Project/File: 233001363

Date: November 30, 2023

**Reference: St. Anthony Mine – Pit 1 Backfill and Design Concept**

Attachment: Updated Draft Pit 1 Drawings for the St. Anthony Mine 90% Closeout Plan: Sheet 8 Existing and Final Conditions, Sheet 10 Pit 1 Highwall Cross Section A, Sheet 11 Pit 1 Highwall Cross Section B, Sheet 12 Pit Highwall Cross Section C, Sheet 24 Diversion Channel Details (2 of 4), Sheet 26 Cover System Details (4 of 4)

UNITED NUCLEAR CORPORATION  
ST. ANTHONY MINE; CIBOLA COUNTY, NEW MEXICO  
PIT 1 EXISTING AND FINAL CONDITIONS

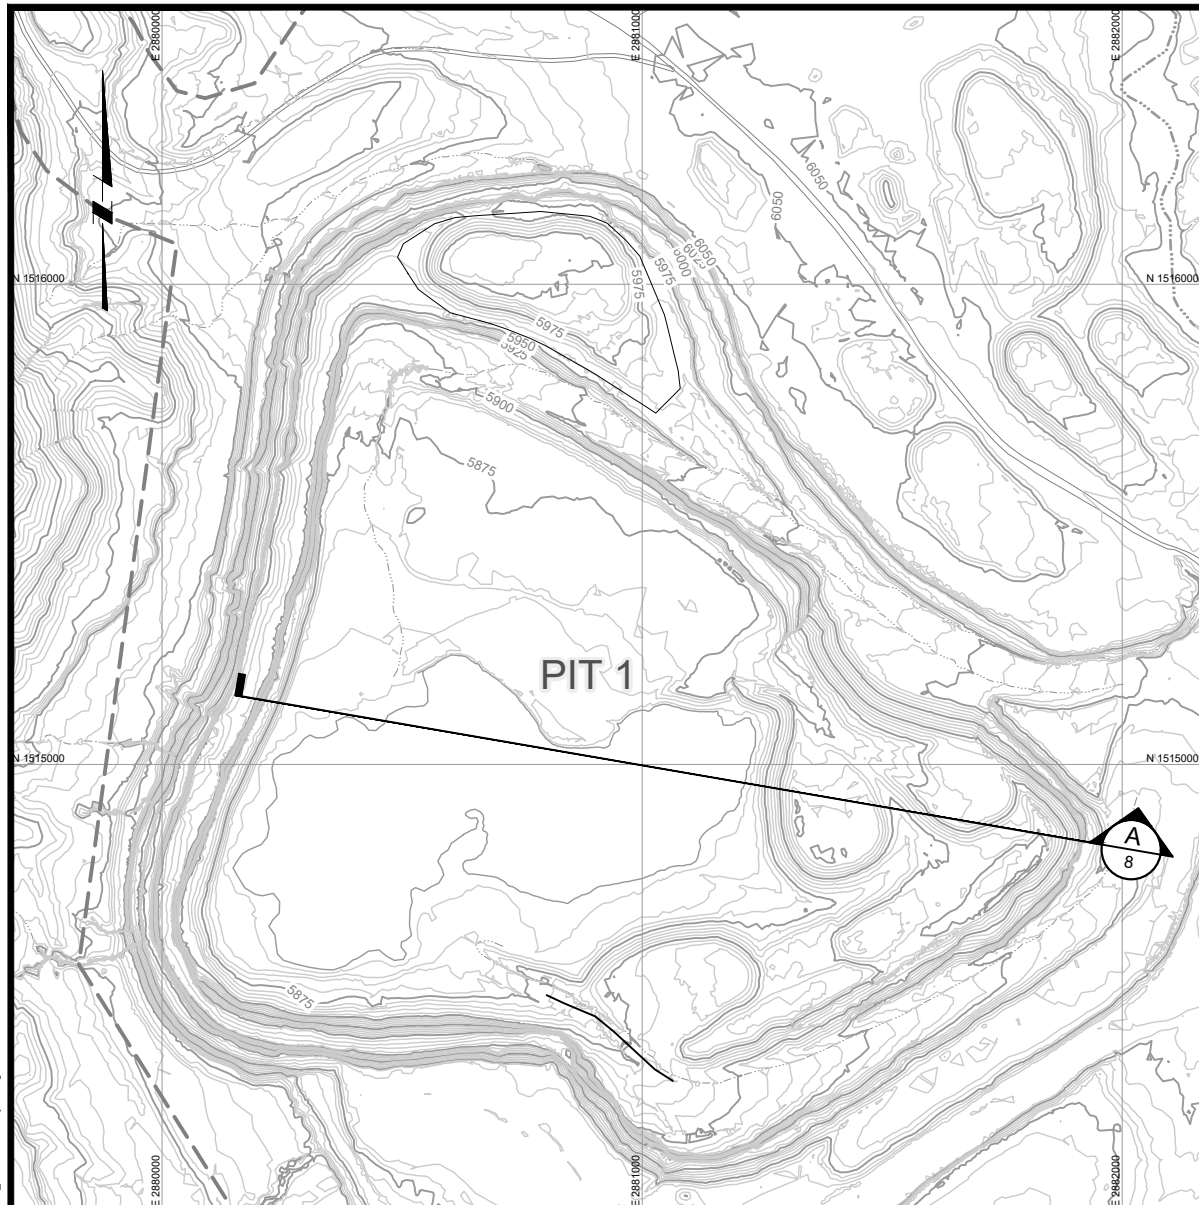
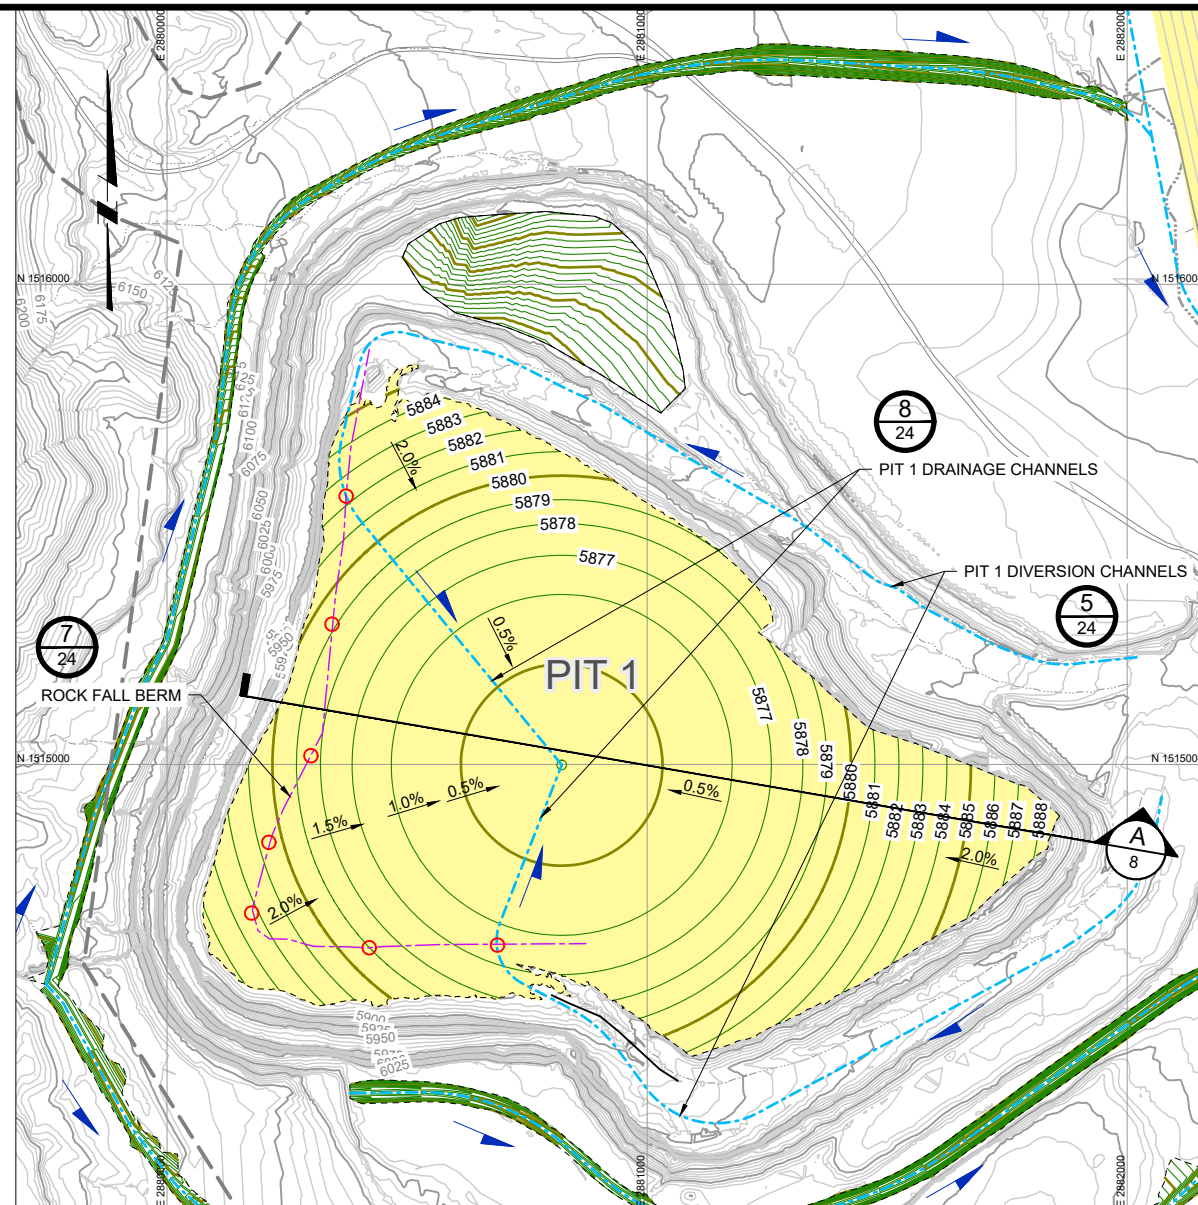
- A rockfall berm will be constructed along the highwalls and on the Pit 1 cover to collect potential rockfall off the pit walls and contain it near the outer perimeter of the cover. The variable distance between the highwall and the rockfall berm is based on rockfall and runout analyses previously completed for several locations along the west and southwest portions of the highwall. The rockfall berm will include intermittent breaks to prevent meteoric water from being trapped behind the berm. Additional details have been added to the drawings for a proposed rockfall berm on the Pit 1 cover (see Sheet 8).

**8** PIT 1 DIVERSION/DRAINAGE CHANNEL DETAIL  
24 (NOT TO SCALE)

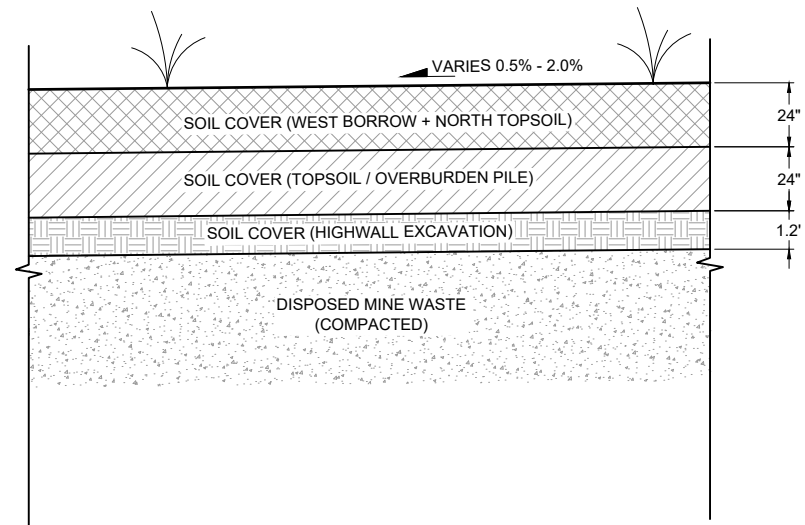
- A new detail for the Pit 1 Drainage Channels (North and South) has been added to the details (see Sheet 24). In addition to the channel dimensions, this detail (Detail 8) shows the underlying cover layer thicknesses for sections of the channels that cross the cover surface.

8 COVER DETAIL - PIT1  
26 (NOT TO SCALE)

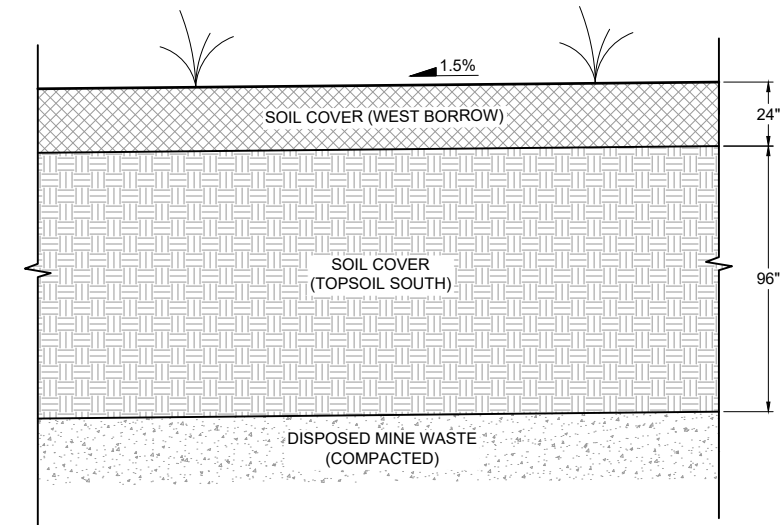
- With this volume adjustment, Stantec re-calculated the radon emanation for the Pit 1 soil cover and refined the overall thickness of the soil cover from 6 feet (48 inches of highwall materials plus 24 inches of West Borrow and North Topsoil) to 5.2 feet (24 inches of mixed West Borrow and North Topsoil + 24 inches of Topsoil Overburden + 14 inches of Highwall materials). These three fill layers comprise the cover and will be placed above the disposed mine waste from the Pit 1 Infill piles (see Sheet 26). Radon model results indicate that the revised cover design will reduce radon emanation to values less than 20 pCi/m<sup>2</sup>-s.
